PREPARED		DART AERO ACCESSORIES INC	
B. Williams		VICTORIA INTERNATIONAL AIRPORT, CANADA	
CHECKED		D2156	
DATE		TITLE	
Nov. 30, 1994		VENT FLANGE	
A		REV. 1	
96/02/04		SHEET 1 OF 1	
M/F D2000 ALUMINUM 45000		SCALE	
		1:1

From: David Shepherd [dshepherd@dartaero.com]
Sent: November 3, 2010 11:11 AM
To: 'Marc Bellavance'
Cc: 'Mike Petsche'; 'Eric Downing'; 'Jason Murdoch'
Subject: RE: D2156 Vent Flange (Ref. D206-575-011)

ENGINEERING CHANGE NOTICE
DART AEROSPACE LTD

Reason for Change:
REVISION OF D2156 REQUIRED TO REFLECT CURRENT MANUFACTURING PROCESS.

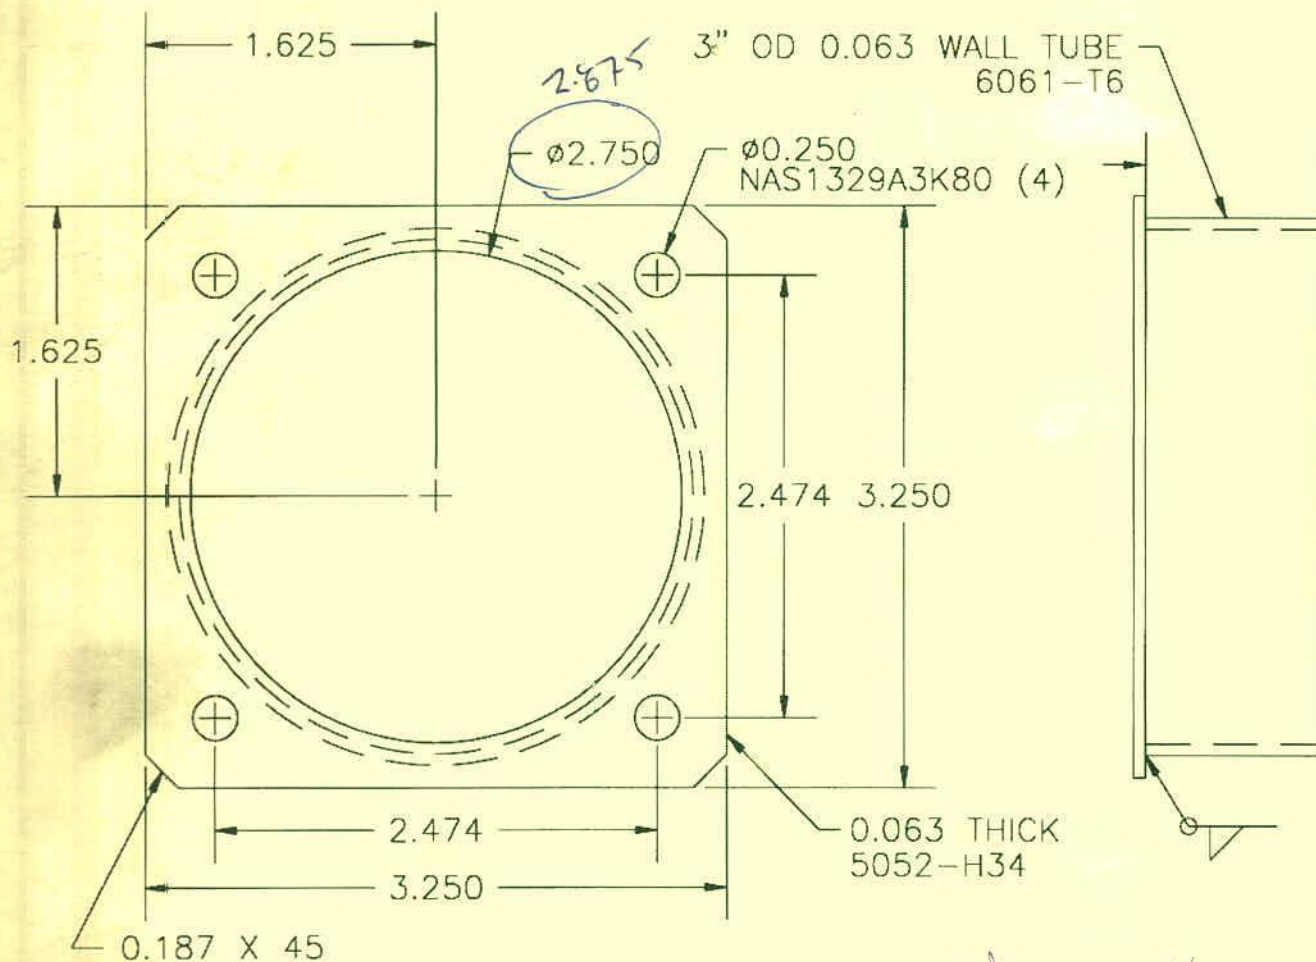
Eric Downing and I have verified the fit of a Sceet 12 with the flange and we don't see a problem using the spun part which P/N is D2156.

I don't have a problem with the change as long as the part will function in service. In fact, I believe this is what is meant by Jim's handwritten note, which says "Make from D2000 aspirator". Will the part mate properly with the required hoses if its made to the new dimensions? What is the p/n of the spun part in the photograph?

I inherited a W/O here for D2156 Vent Flange dated... 11/09/09... We need to ship qty(1) D206-571-011 Heater soon and the part in question is not conforming to the drawing as follows:

1. Drawing specifies a welded assembly, we have a spunned part which requires drilling of holes and the flange has to be cut to shape on drawing;
2. The major ID is Ø2.875" instead of Ø2.750";
3. The height of the sceet connection is 0.970" instead of 1.000".

The reason to have the part spunned is to reduce cost so manufacturing would like to have the drawing revised accordingly as well as authorization to use the non-conforming parts to complete the PO and ship on time.

Proceed with the dwg change.

Documents Affected:
D2156 REV. D
